STANDARD DEPARTURE CHART-INSTRUMENT

RJFN / NYUTABARU

NIPPO SEVEN DEPARTURE

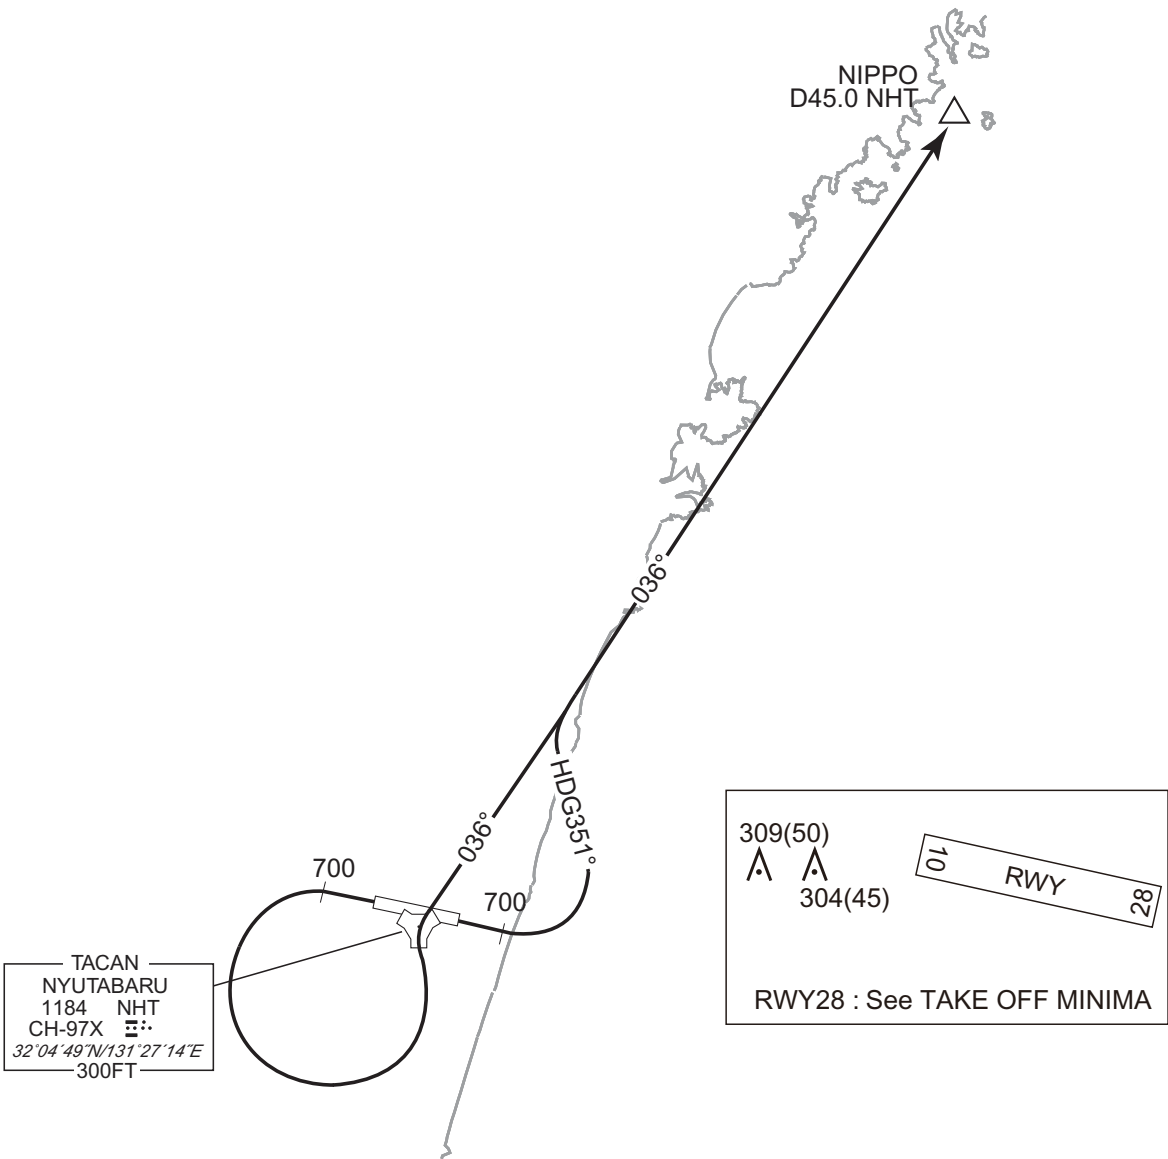
CHANGE : PROC renamed(NIPPO SEVEN DEPARTURE). PROC course(NIPPO SEVEN DEPARTURE). YATOJI TWO DEPARTURE abolished.
Restriction. Note, OBST added.

TENSO FOUR DEPARTURE

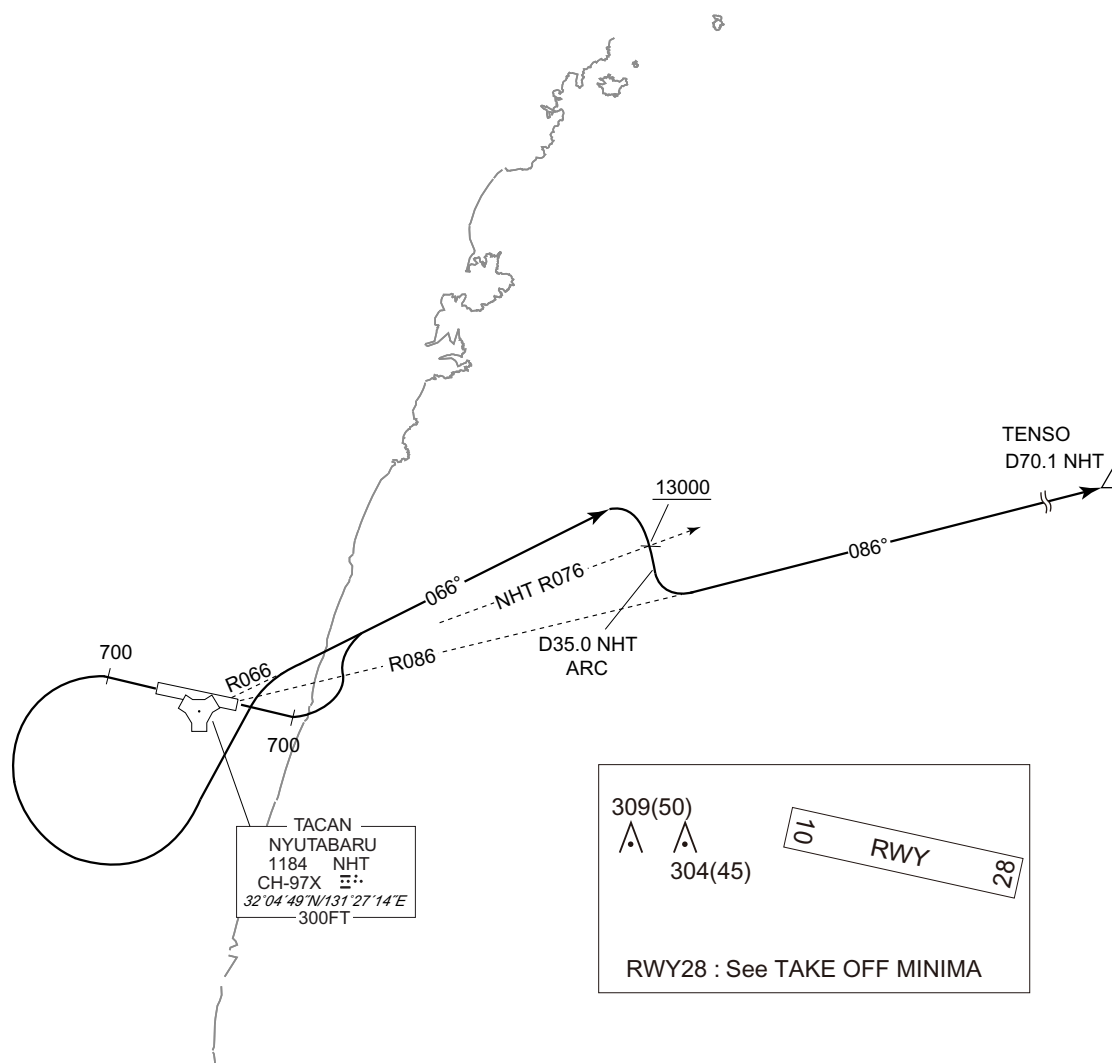
CHANGE : PROC renamed. PROC course. Restriction. Note, OBST added.

SAITO ONE DEPARTURE

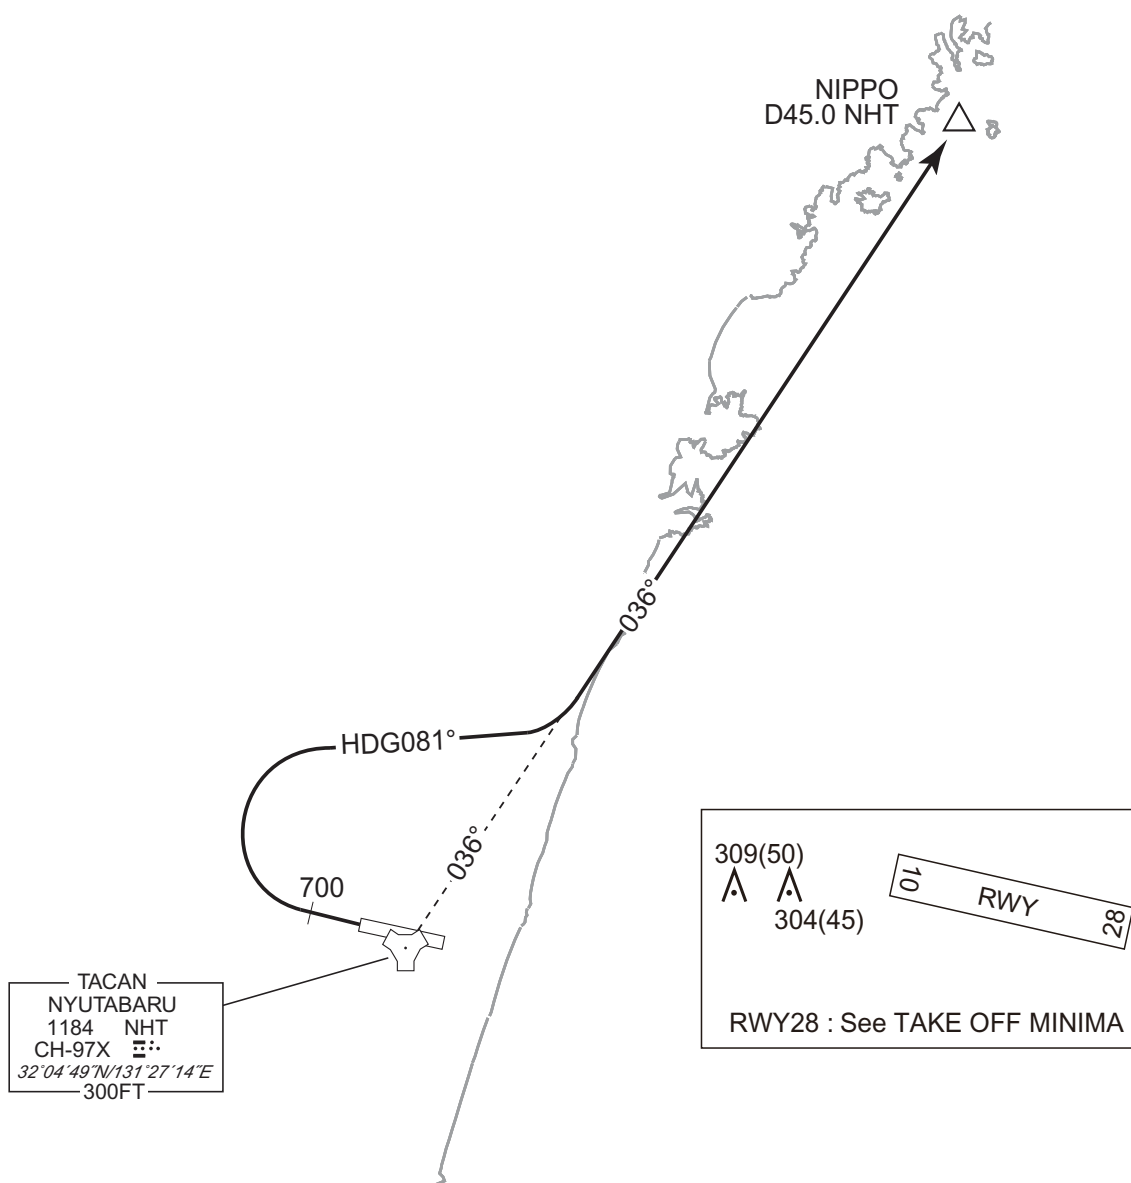
CHANGE : New PROC.

TRANSITION

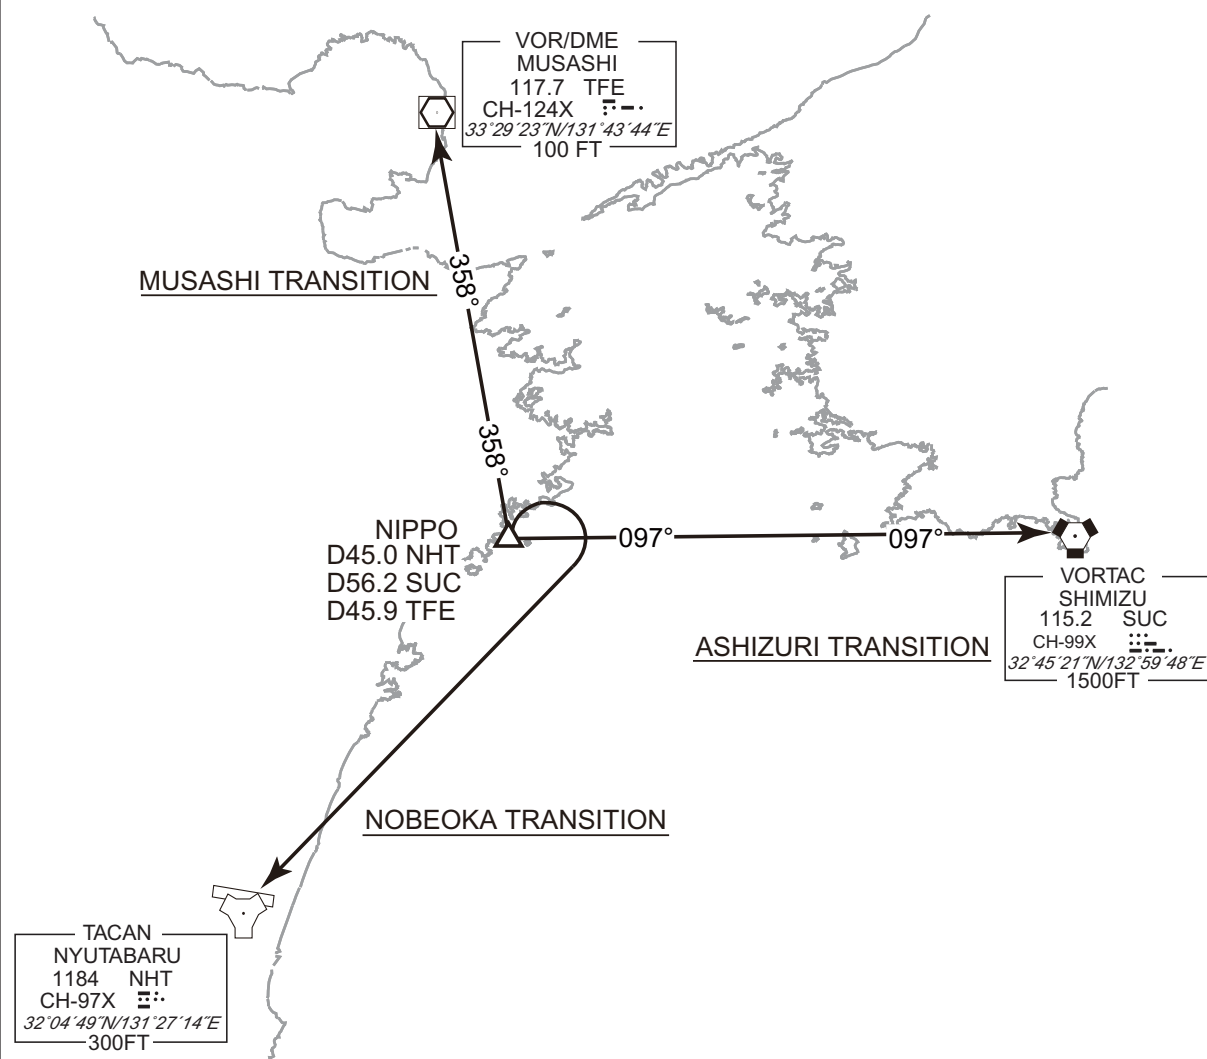
CHANGE : PROC course(NOBEOKA TRANSITION). Description of ASHIZURI TRANSITION, MUSASHI TRANSITION, MUSASHI TRANSITION. ALT restriction.
SOBO TRANSITION abolished.

TENSO ARRIVAL

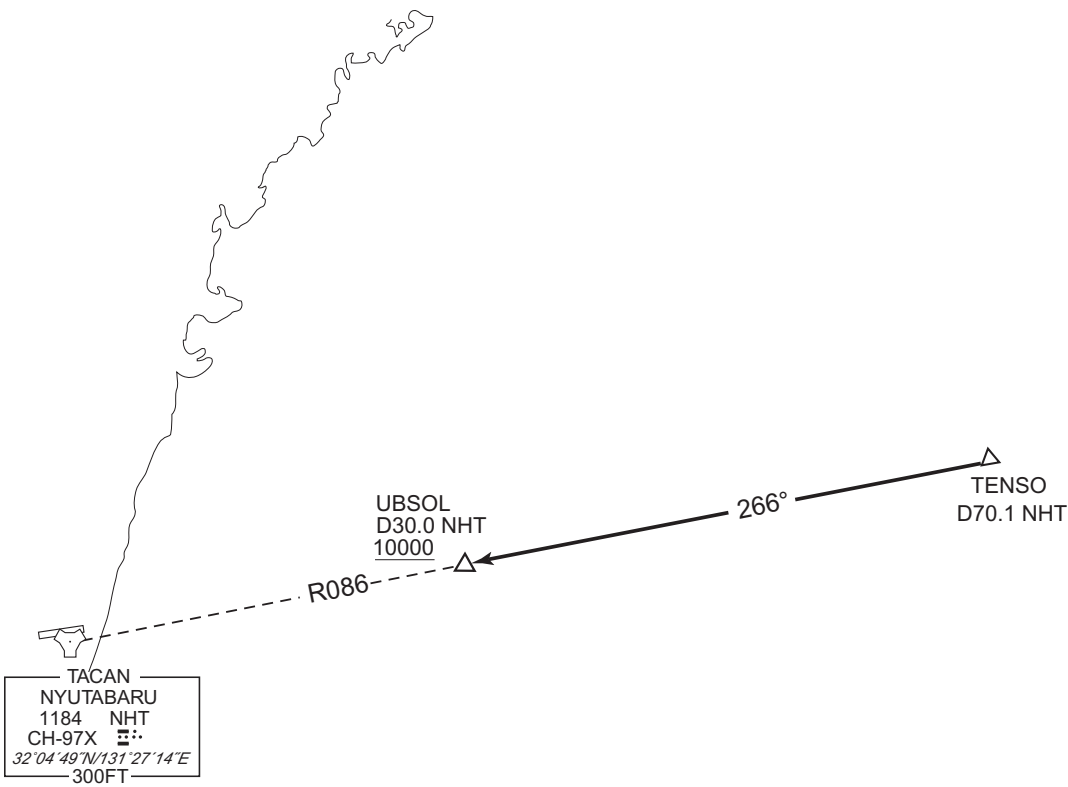
CHANGE : PROC course. UBSOL established. ALT restriction.

TACAN Z RWY28

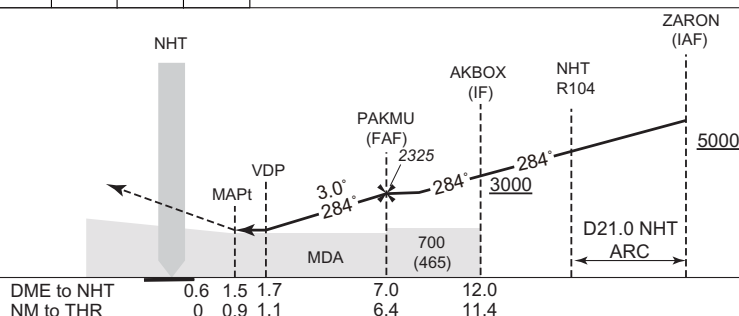
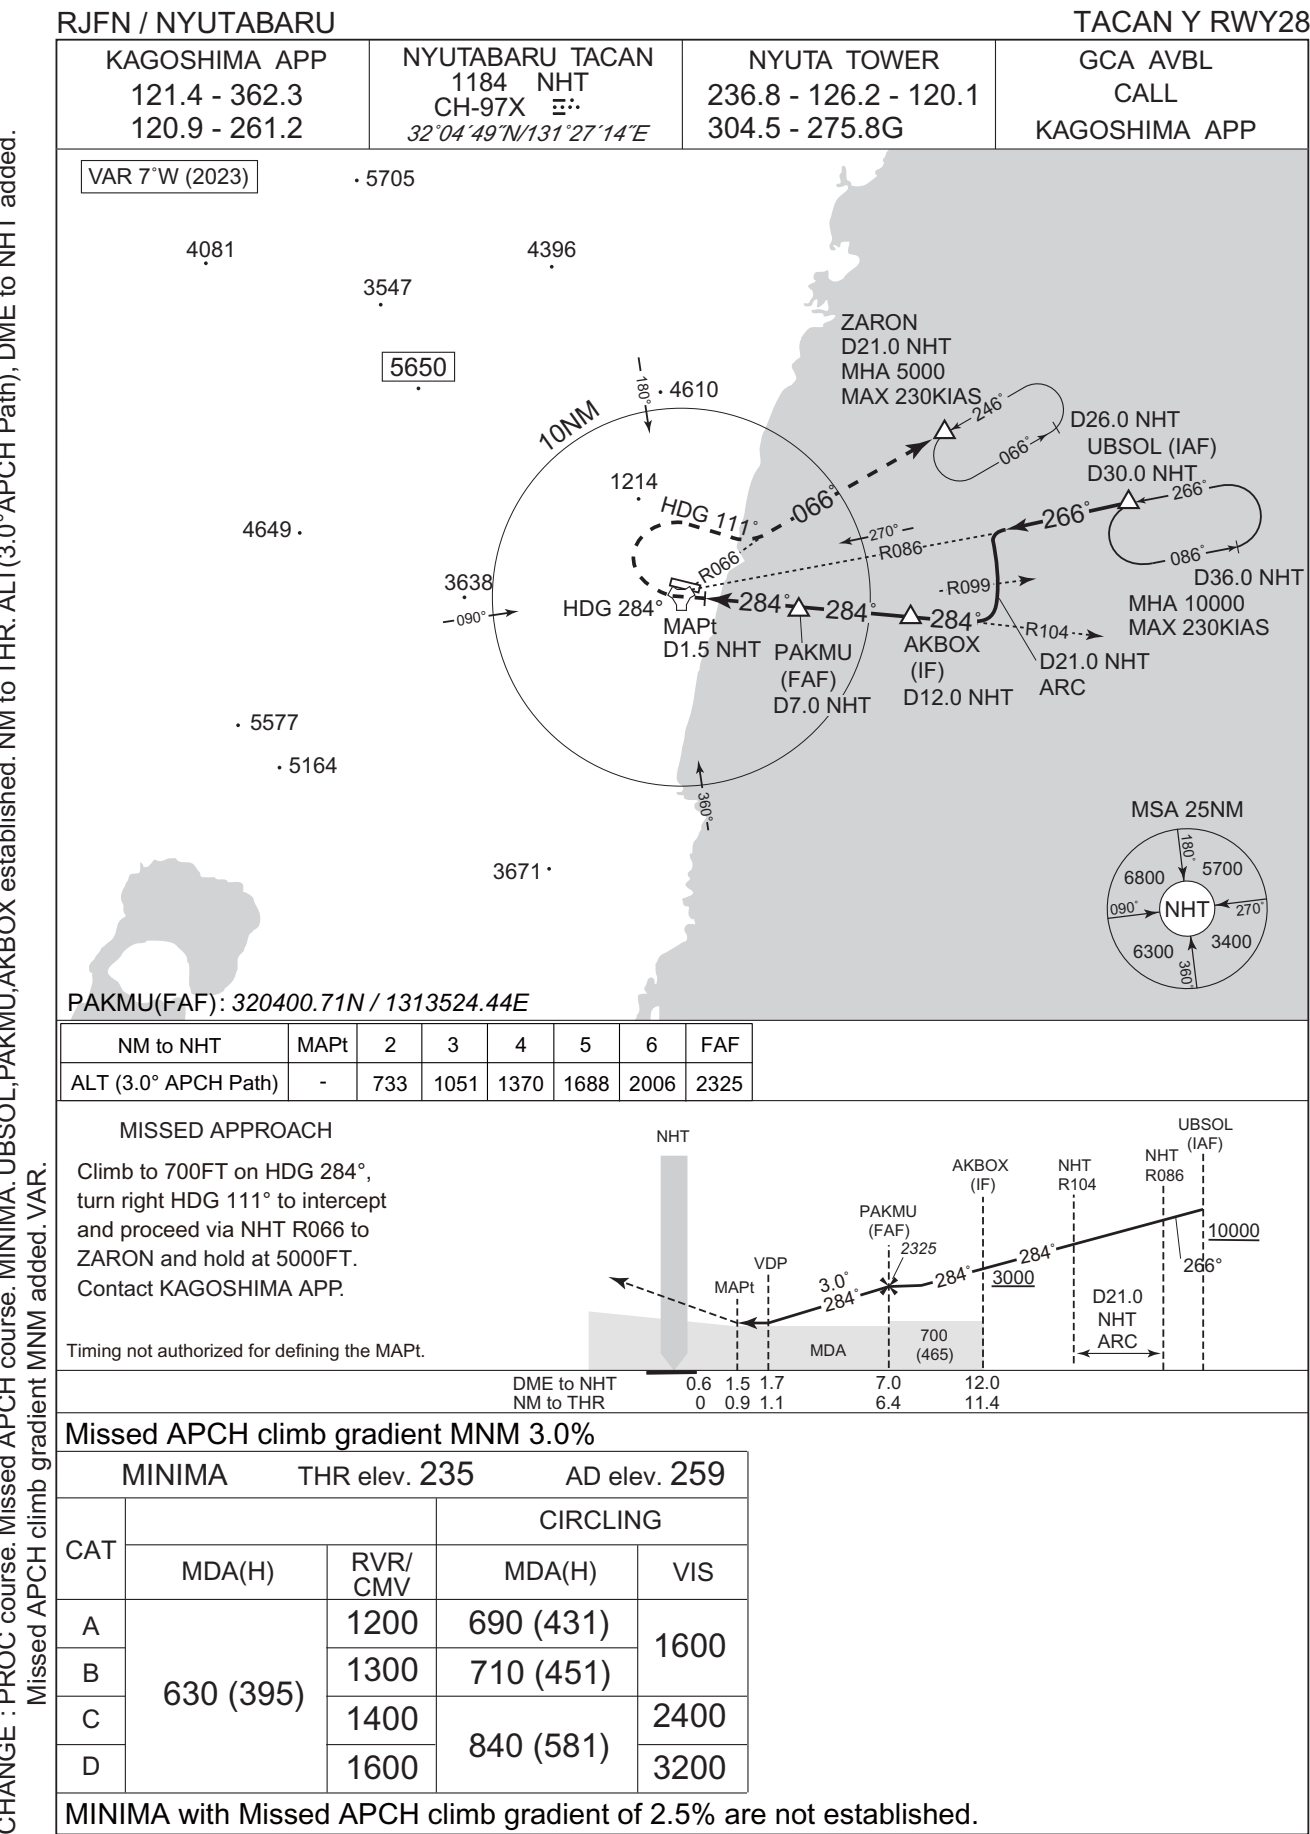
CHANGE : PROC course. Missed APCH course. MINIMA. PAKMU,AKBOX established. NM to THR. ALT(3.0°APCH Path), DME to NHT added. Missed APCH climb gradient MNM added. VAR.
